JRPP No.	2009SYE020
FILE No.	DA 625/2009
PROPOSAL:	The consolidation of the 2 sites, the demolition of the existing pool and alterations and additions to the existing dwelling-house at 40 Wentworth Rd; the total demolition of the existing dwelling-house at 49 Vacluse Rd and the erection of a 2 storey module linked to the dwelling-house on 40 Wentworth Rd containing 7 off-street car parking spaces, gymnasium and pool structure; landscaping and site works.
	40 Wentworth Rd and 49 Vacluse Rd, Vacluse Site Area (m ²): 2839.1 m ² Zoning: Residential 2(a)
APPLICANT:	Mr M Csidei
AUTHOR:	D Booth – Woollahra Council

Assessment Report and Recommendation

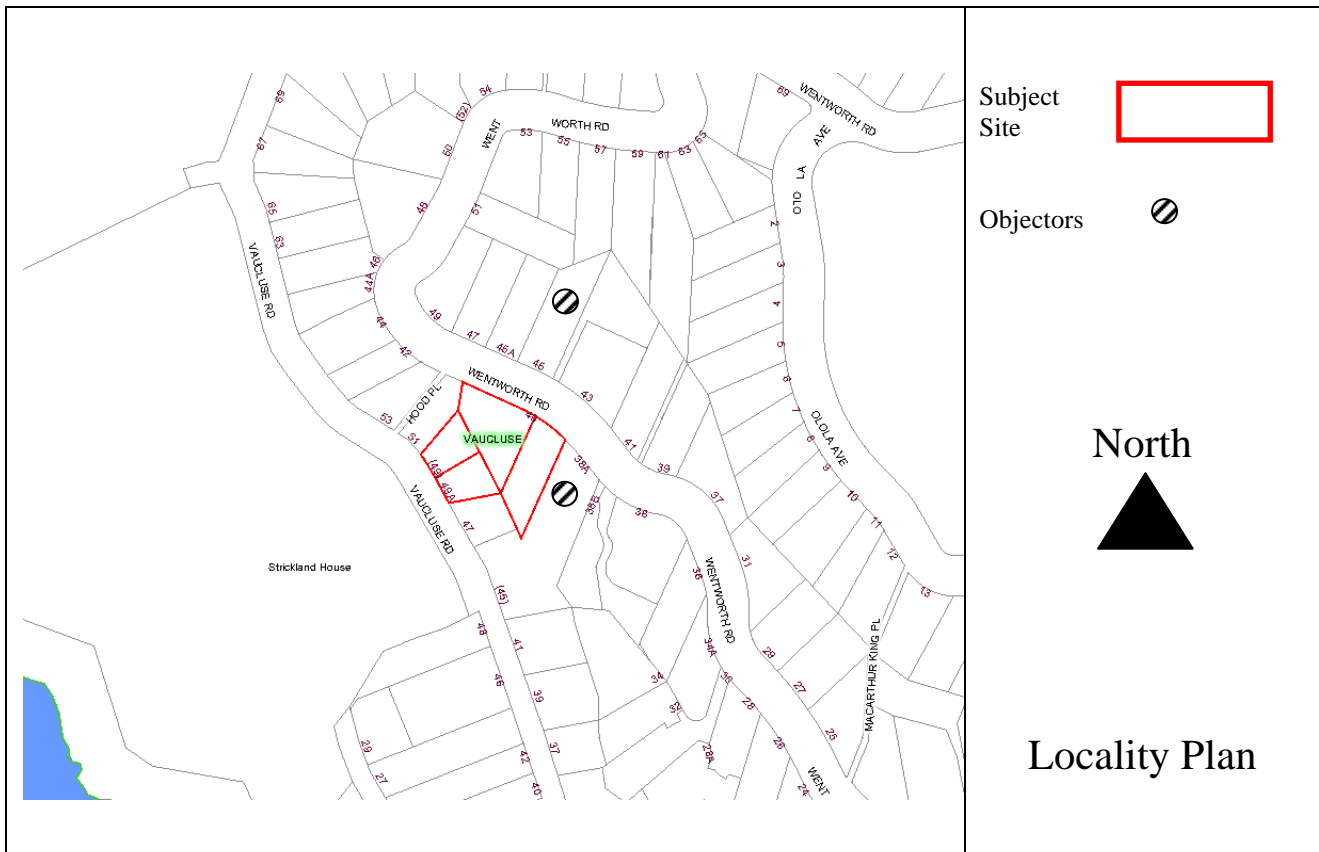
The proposal was amended on 12 February 2010 as follows:

- Minor alterations to the design of the in-fill addition between the eastern and western wings of the existing dwelling-house at 40 Wentworth Rd (in place of the existing swimming pool and internal courtyard) so as to lower the maximum height of the structure from 9.72m to 9.48m (240 mm) in order to remove a technical breach of Council's 9.5 m height standard resulting from existing ground level being the deep end of the existing swimming pool.
- The removal of the proposed excavation from the root zone of several existing Brush Box trees adjacent to the Vacluse Rd frontage.
- The addition of a notation on the southern corner of the site analysis and roof plan that "no planting or structure above RL 46.0" in order to address potential concerns of (38A Wentworth Rd).

Wentworth Road
First Floor Plan

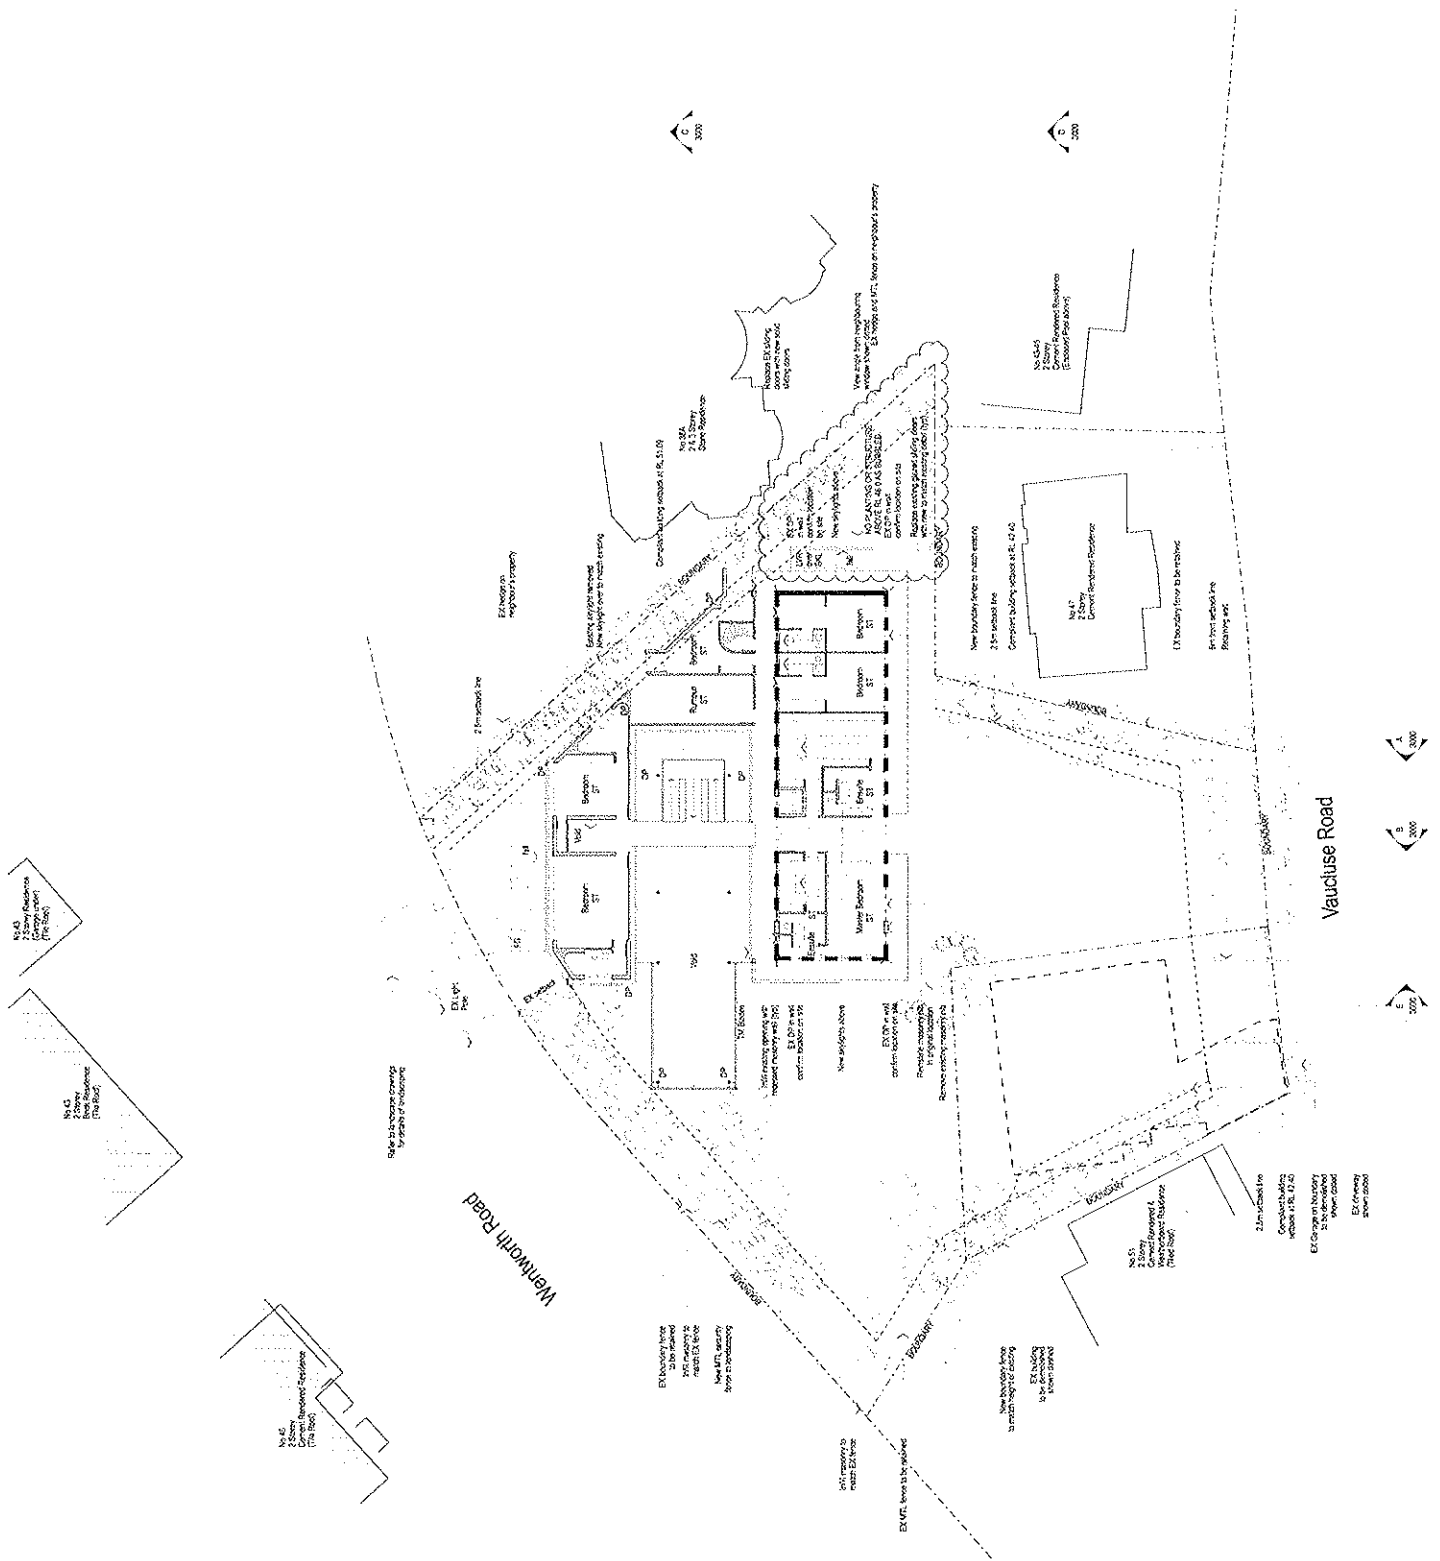
A first floor is proposed to be added to the top of the smaller eastern wing. This wing is currently only just visible from Wentworth Street. The proposed addition retains the parapet and sets the new wall behind. It has a flat roof which has been kept as low as possible and aligns with the original western wing roof and the proposed courtyard roof. The proposed building is kept neutral and is clearly distinguishable over the eastern wing.
